Technical Service Information

CHRYSLER A604 REVISED 2-4 CLUTCH PISTON RETAINER

Figure 1

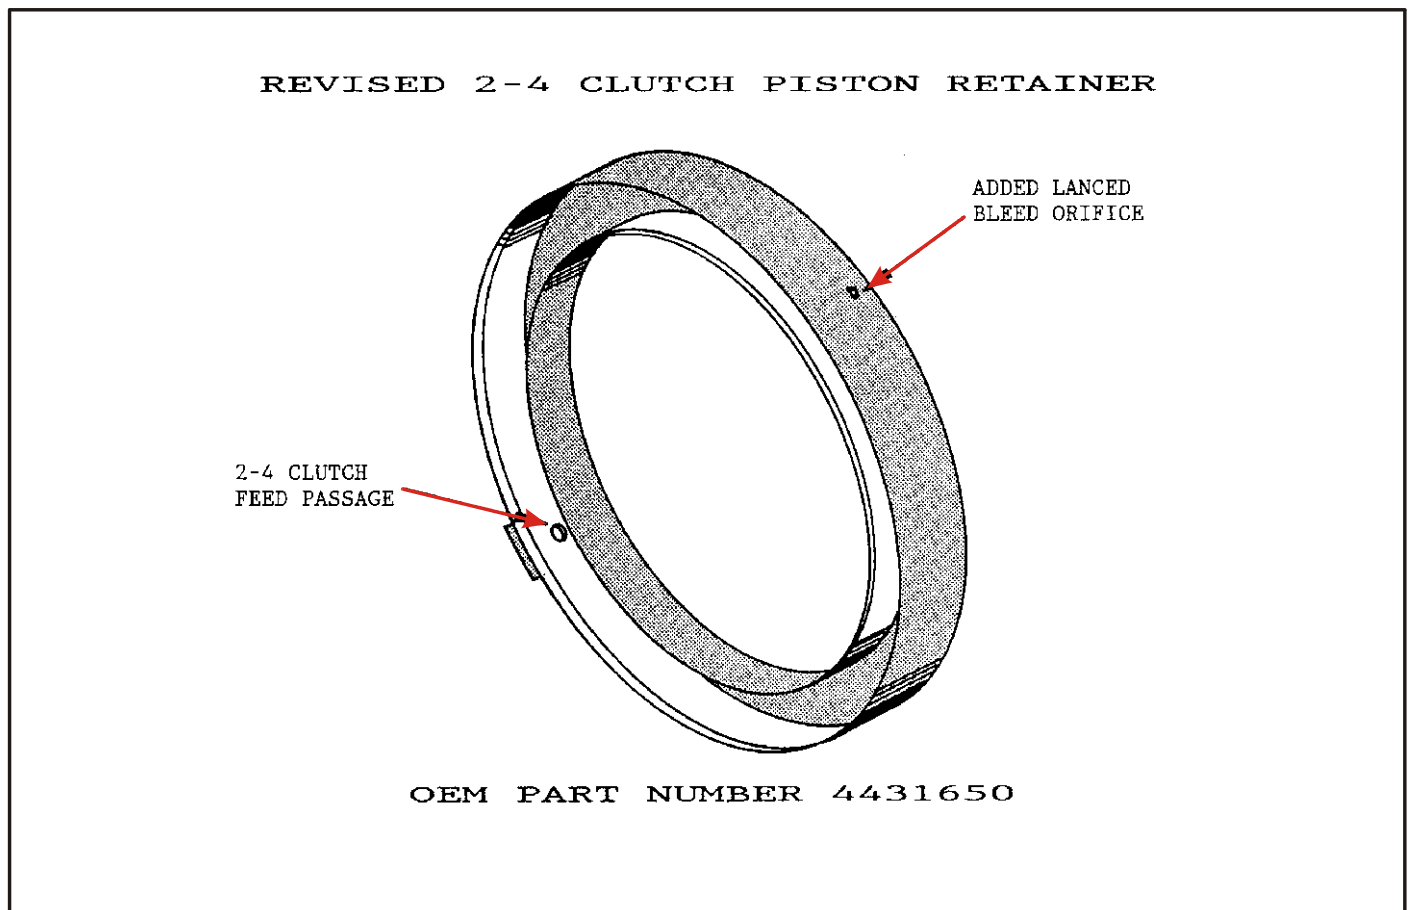
CHANGE: Beginning at the Start Of Production for the 1995 model year, all Chrysler A604 (41TE) and A606 (42LE) transaxles were produced using a revised 2-4 Clutch Piston Retainer with an added lanced bleed orifice (See Figure 1).

(1) 2-4 CLUTCH PISTON RETAINER - Lanced bleed orifice added to the retainer in the location shown in Figure 1.

The revised 2-4 Clutch Piston Retainer with the added lanced bleed orifice will back service ALL previous models of Chrysler A606 (41TE) and A606 (42LE) transaxles.

There was not a part number change, so the revised retainer is available under OEM part number 4431650.
